Addendum No. 1

ISSUED BY: Great River Engineering
2826 S. Ingram Mill Rd.
Springfield, Missouri 65804
(417) 886-7171

DATE: January 25, 2024

FOR: Shelbina Lake Bridge Replacement and Spillway Improvements
GRE Project # 4514

C3

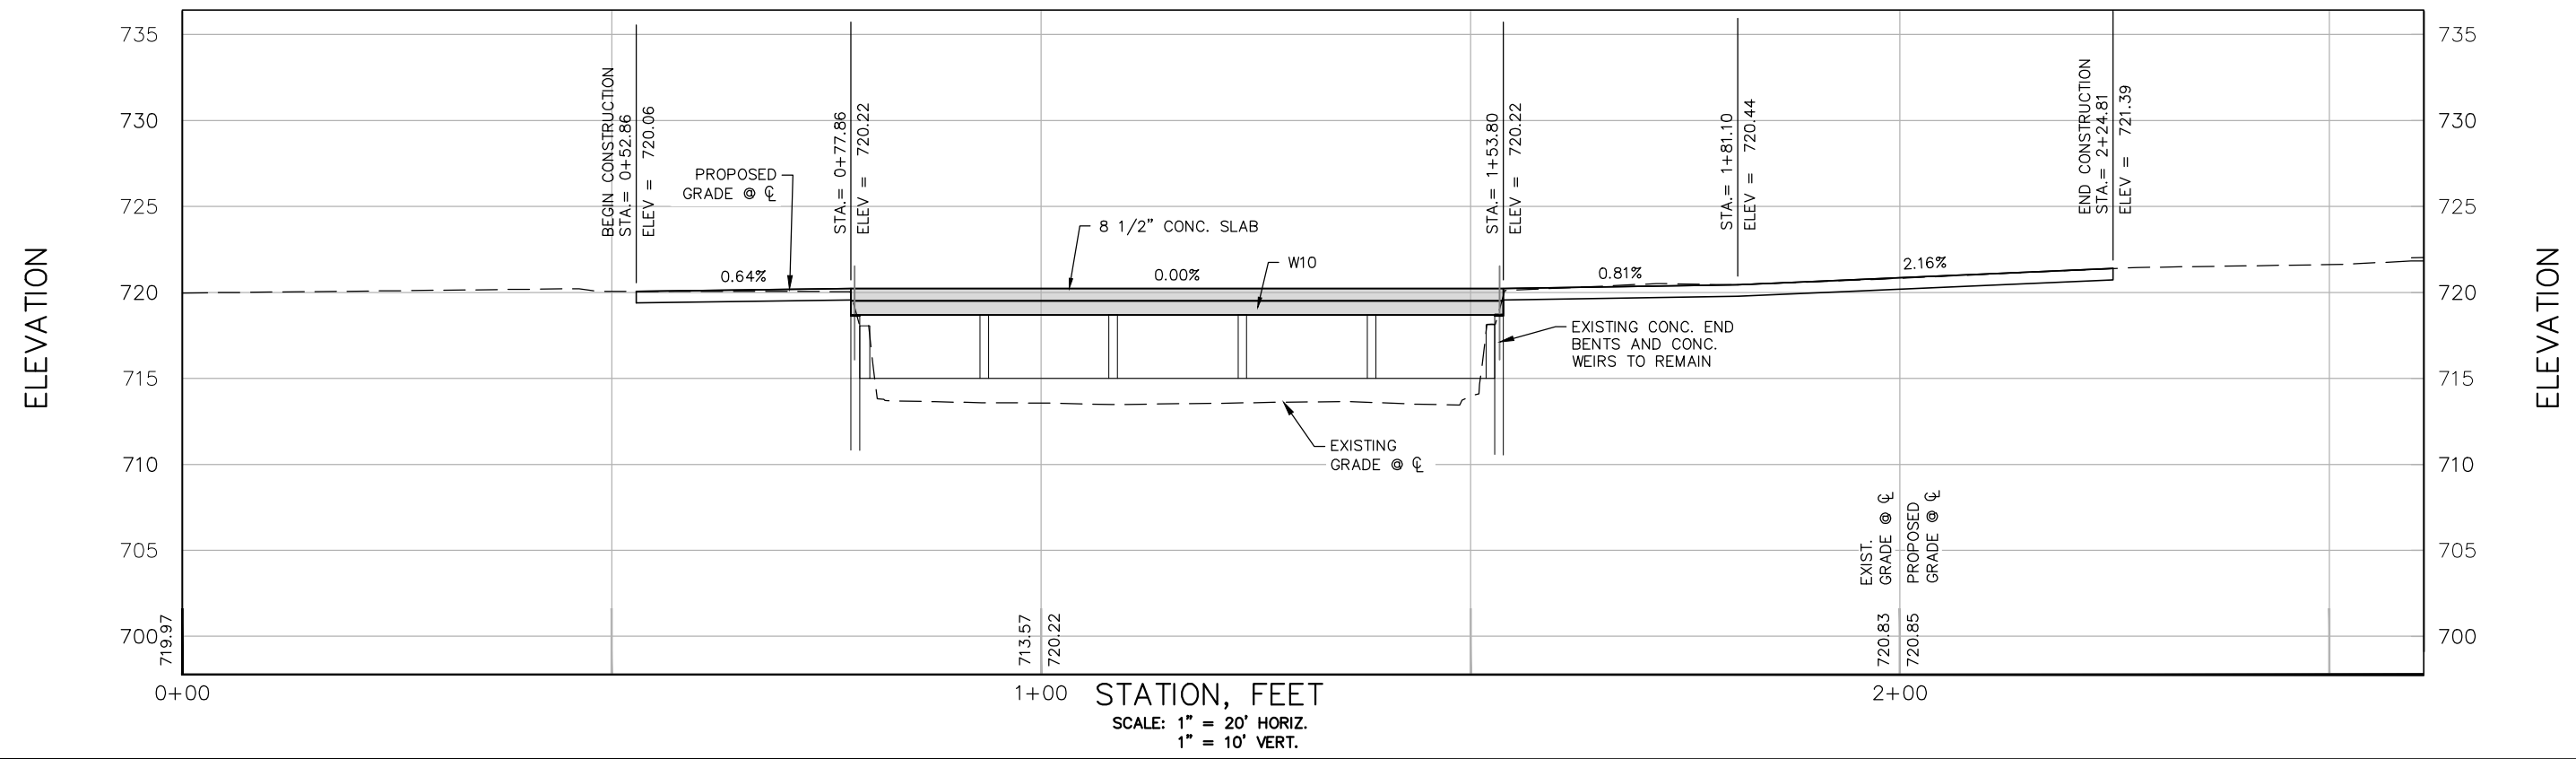
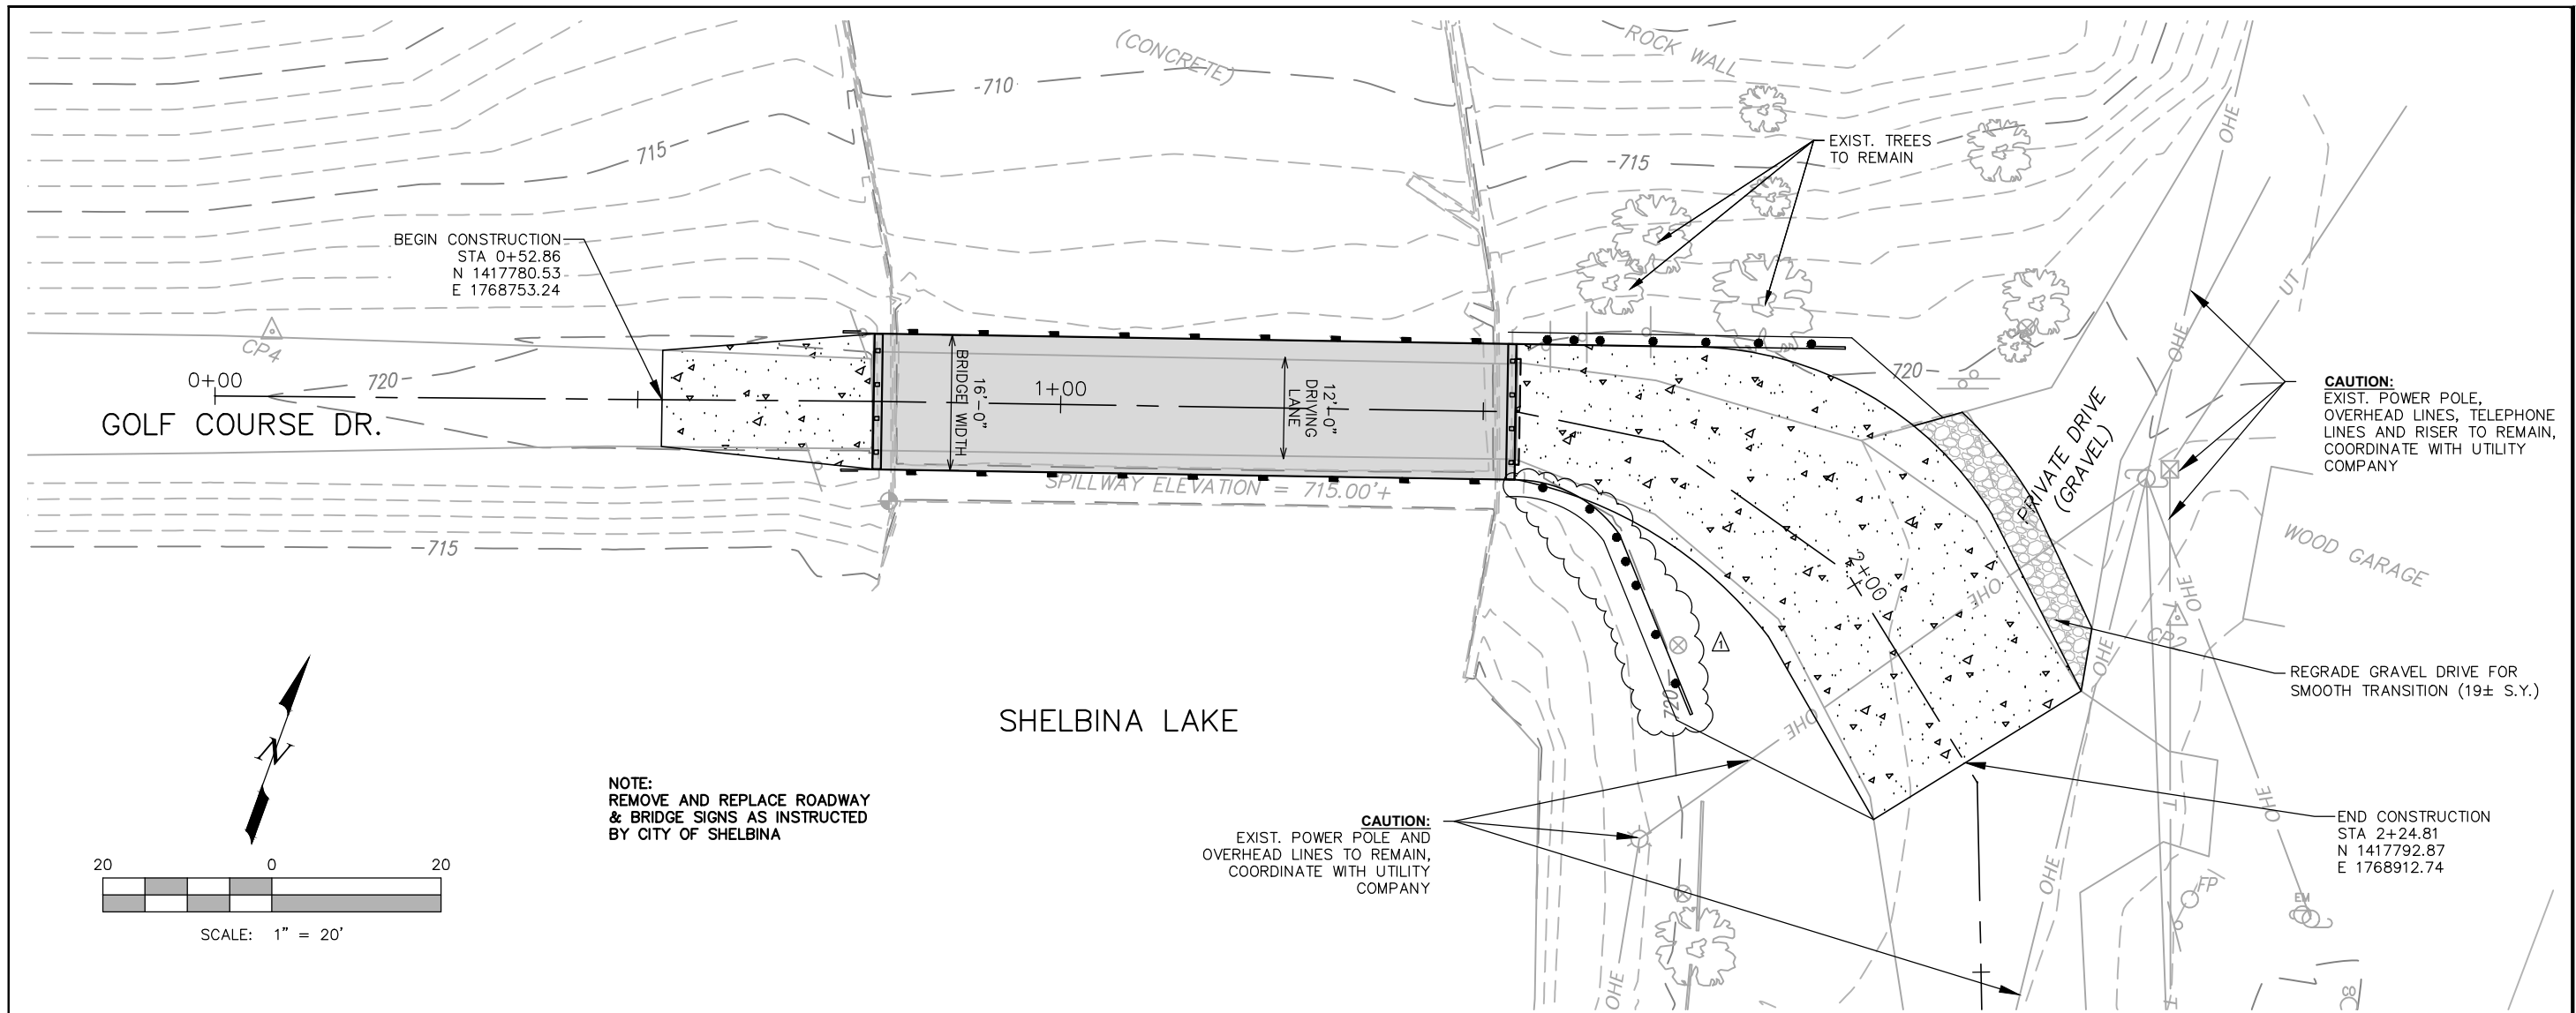
- a. SHEET C2 – Roadway quantity “Type A Guardrail” was changed to 37.5 L.F.
- b. SHEET C3 – Plan view was updated to reflect changes made to guardrail.

Date	1/24/2024
Revision/Issue	GUARDRAIL LAYOUT CHANGED
No.	1

GOLF COURSE DR. BRIDGE #39650021
CITY OF SHELBYNA, MISSOURI
GIRDER LAYOUT DETAILS

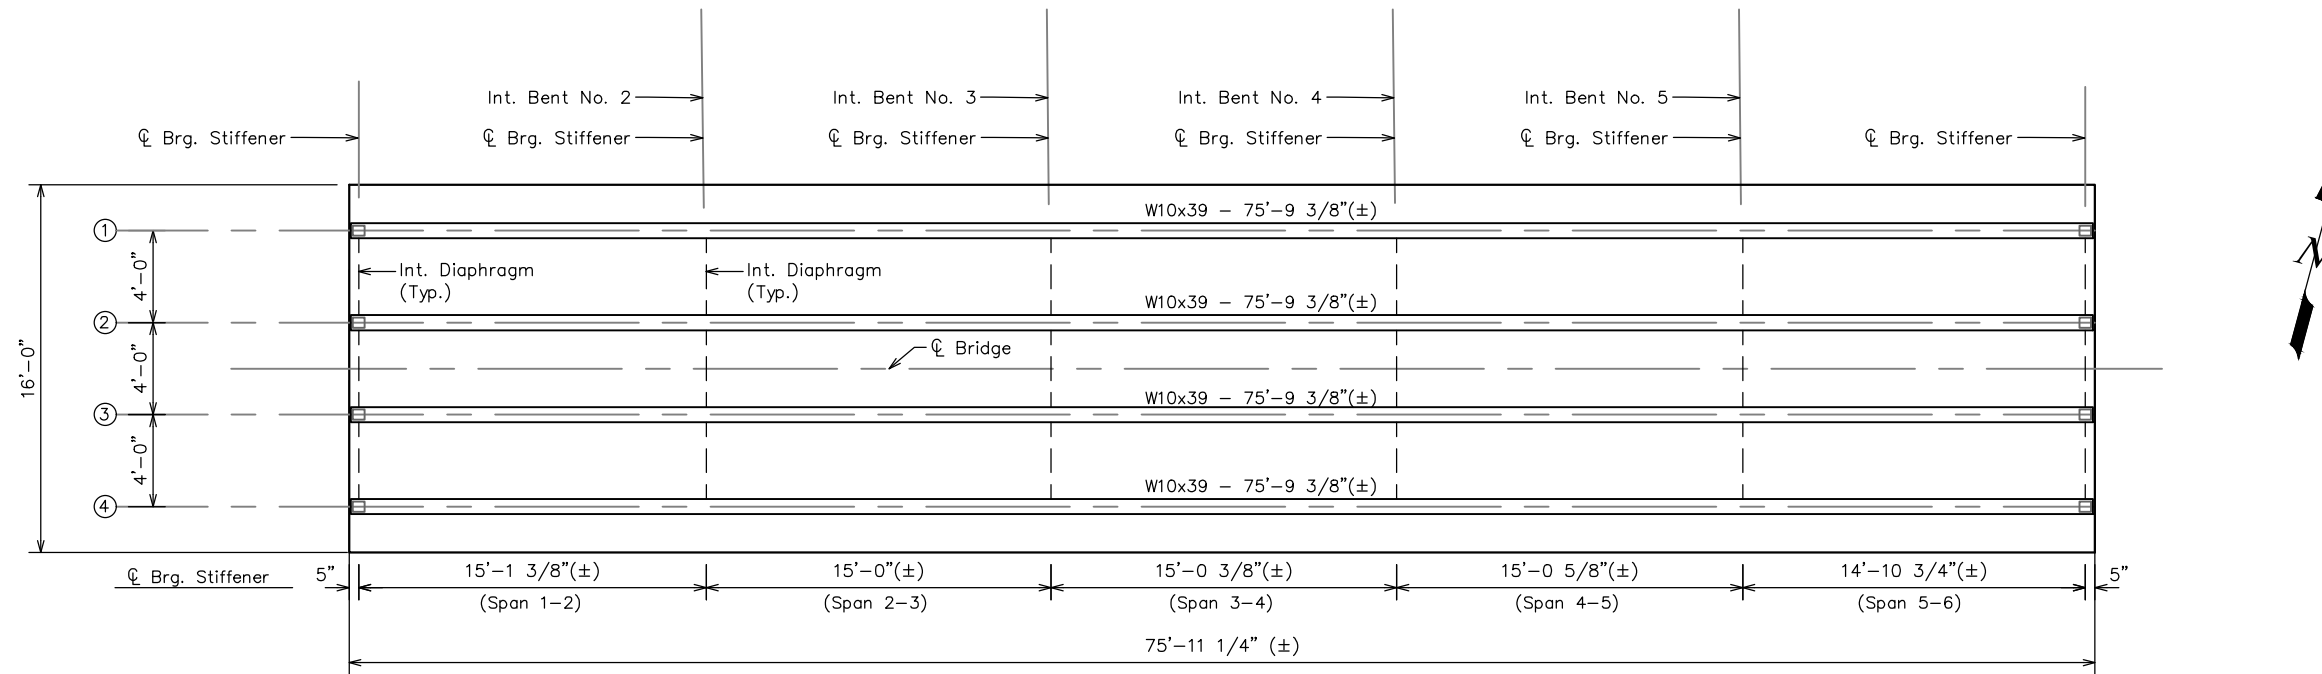
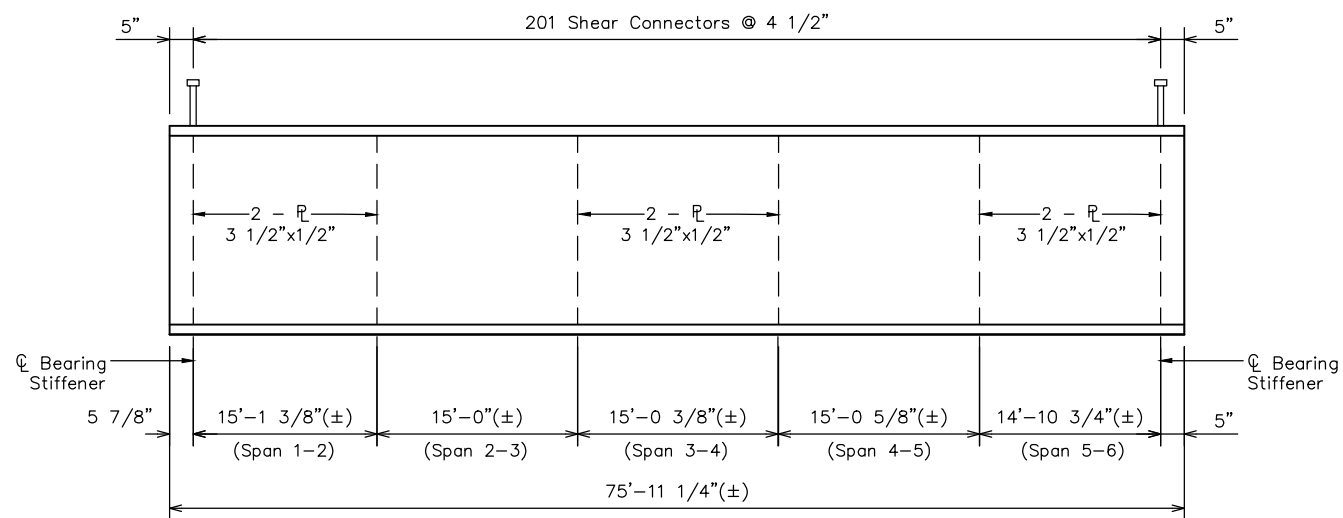
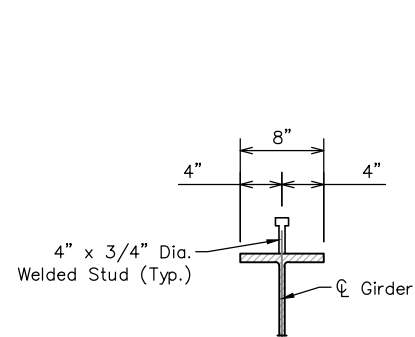
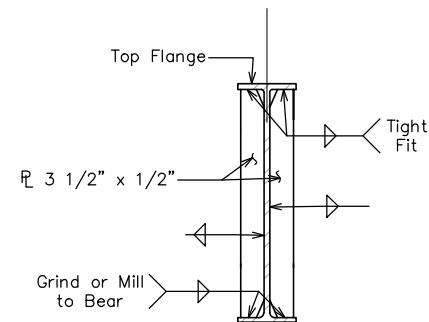
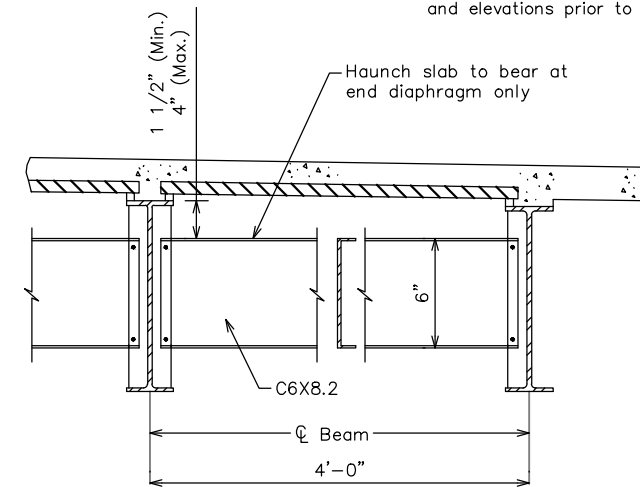
- e. SHEET S7 - General Notes were updated to include the option of using Grade 50 (Galvanized) as an alternative to the Grade 50W for the Fabricated Structural Low Alloy Steel (I-Beam).

Date	1/24/2024
Revision/Issue	ADDED NOTE FOR GALVANIZED A.L.T.
No.	1

Fabricated structural steel shall be ASTM A709 Grade 50W or Grade 50 (Galvanized) except as noted.

Galvanized Alternative: Structural steel shall be galvanized in accordance with ASTM A123 and Sec 1081. No additional payment will be made for galvanizing. All costs associated with galvanizing beams is to be included in the cost of the beams.

PLAN

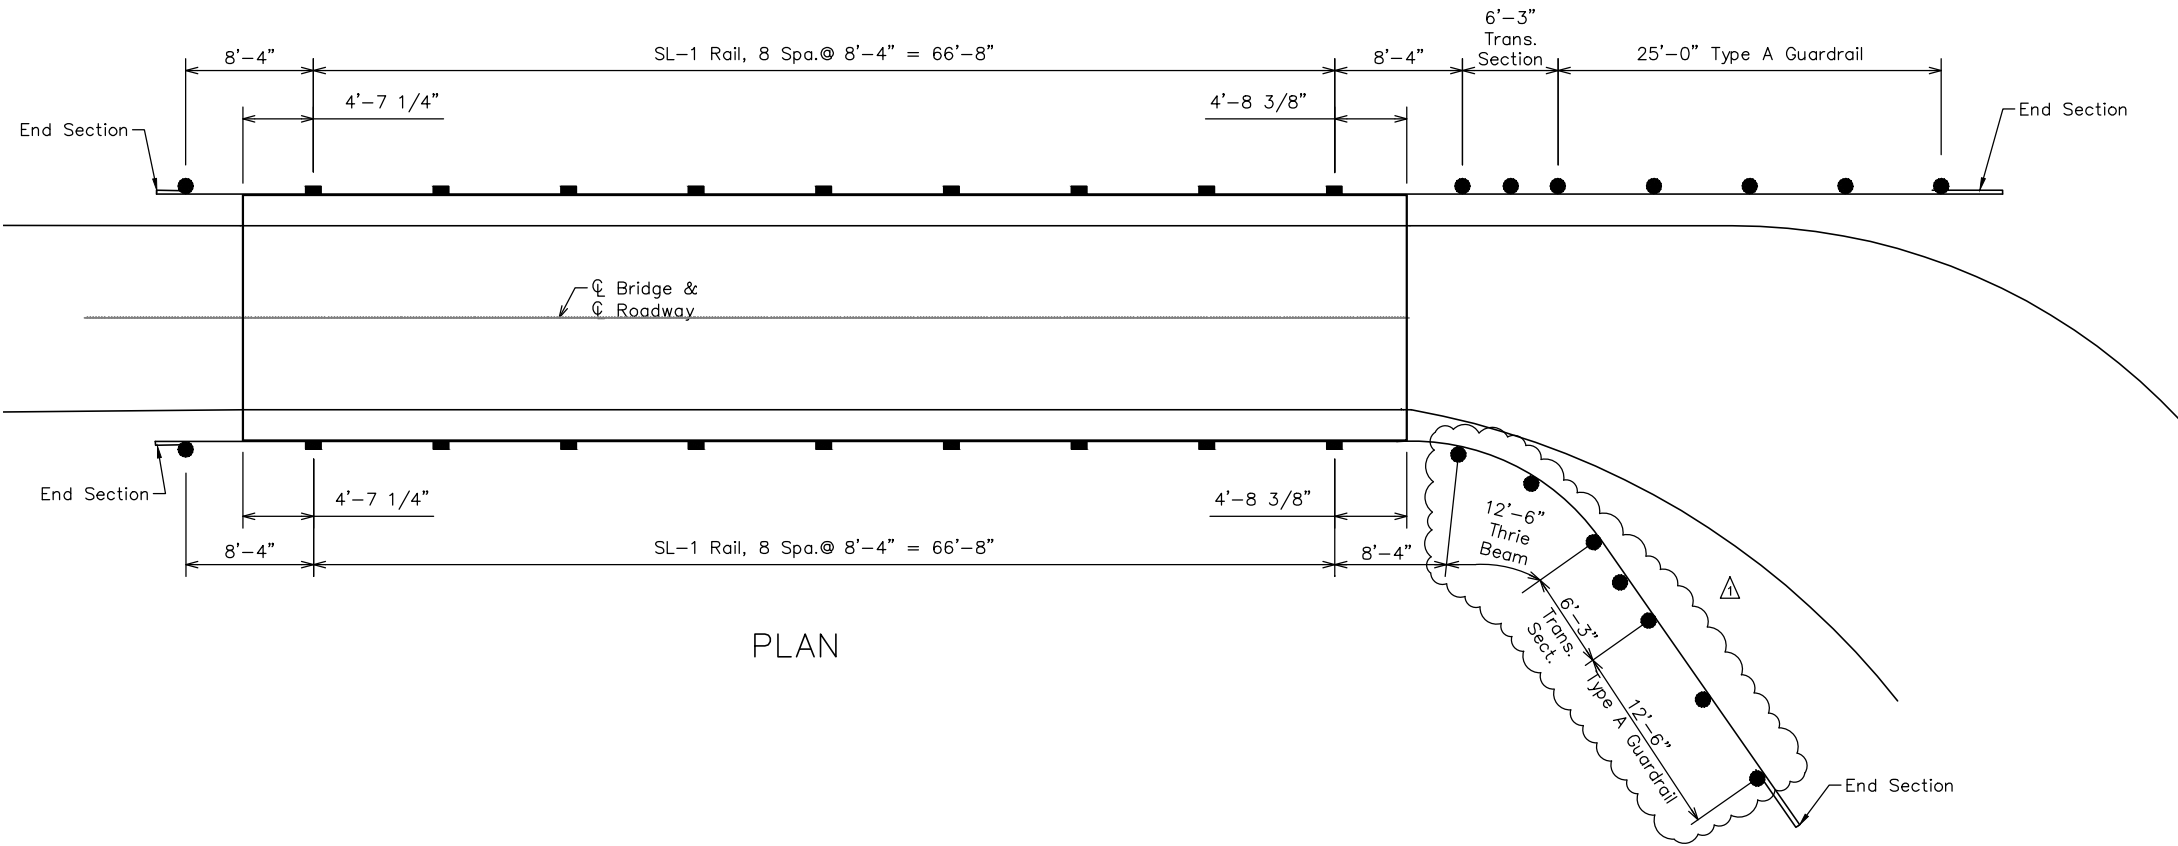
- f. SHEET S9 – Guardrail layout and labels were changed in the plan view.

Date	1/24/2024
Revision/Issue	GUARDRAIL LAYOUT CHANGED
No.	1
